CITY PLAN COMMISSION**THURSDAY, FEBRUARY 20, 2025****FILE NUMBER:** S245-081**SENIOR PLANNER:** Sharmila Shrestha**LOCATION:** Wadsworth Drive, south of Ledbetter Drive**DATE FILED:** January 23, 2025**ZONING:** TH-3(A)**CITY COUNCIL DISTRICT:** 4**SIZE OF REQUEST:** 1.951-acres**APPLICANT/OWNER:** 2SP Developers, LLC

REQUEST: An application to replat a 1.951-acre (84,984.94-square foot) tract of land containing part of Lots 3 and 4 in City Block 5835 and part of City Blocks 5835 and 5836 to create 13 residential lots ranging in size from 3,500 square feet to 7,000.71 square feet and one common area on property located on Wadsworth Drive, south of Ledbetter Drive.

PRELIMINARY PLAT
TOWNSHIP 10N, RANGE 14E, SECTION 36, DALLAS COUNTY, TEXAS
BEING PART OF CITY BLOCK 6846 & 6848
CITY OF DALLAS, DALLAS COUNTY, TEXAS
CITY PLAN FILE NO. 5246-001

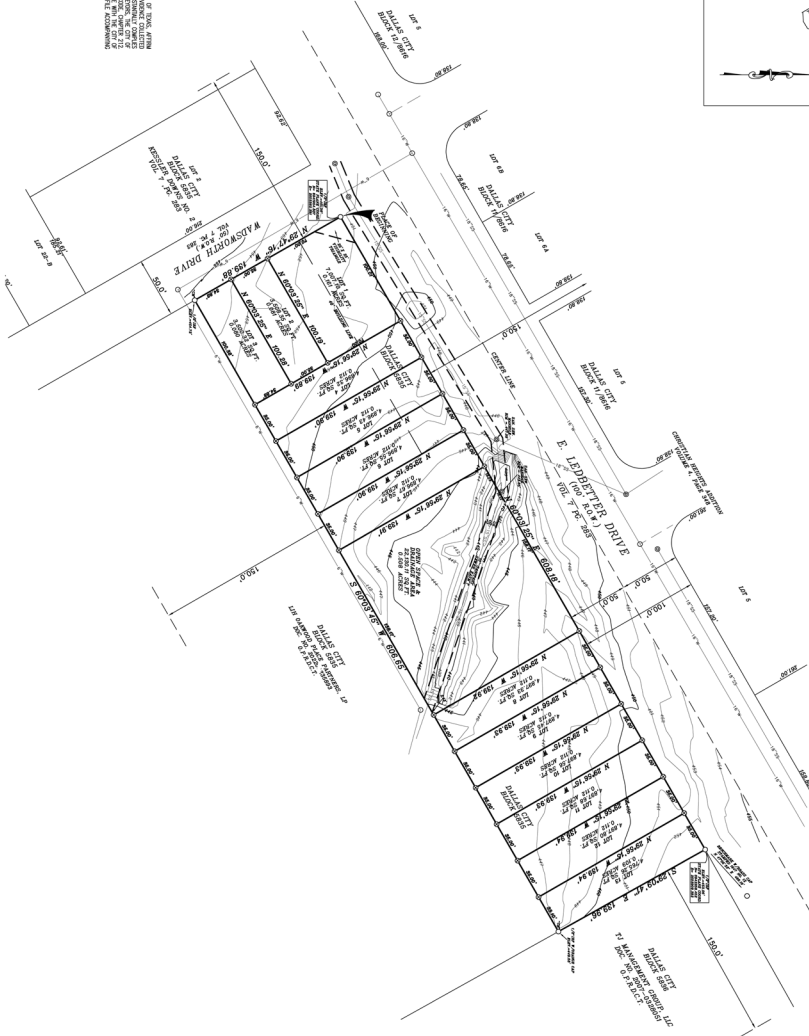
20. Prior to final plat, submit a completed final plat checklist and all supporting documents.
21. On the final plat, add/show Lien Holders Subordination Agreement.
22. On the final plat, show how all adjoining right-of-way was created. Section 51A-8.403(a)(1)(A)(xxii).
23. On the final plat, show recording information on all existing easements within 150 feet of the property.

24. On the final plat, show all additions or tracts of land within 150 feet of the property with recording information. Platting Guidelines.
25. On the final plat, show or list the prior plat on the map, in the legal description, and/or title block. Platting Guidelines.
26. On the final plat, clarify common area.
27. On the final plat, show volume 69067, page 25, deed records, Dallas County, Texas.
28. On the final plat, clarify easements volume 69114, page 861 and volume 69091, page 1949, deed record, Dallas County, Texas.
29. On the final plat, clarify existing 40 feet building line.

34. Prior to final plat, compliance with City's Street lighting standards including illumination standards, material, installation, and activation per Street Design Manual.
35. On the final plat, change "Wadsworth Drive" to "Wadsworth Drive (AKA Wadsworth Street". Section 51A-8.403(a)(1)(A)(xii).
36. On the final plat, add "Brixey Drive".
37. On the final plat, change "E. Ledbetter Drive" to "Ledbetter Drive". Section 51A-8.403(a)(1)(A)(xii).
38. On the final plat, identify the property as Lots 1 through 13 and Common Area "A" in City Block A/5838.
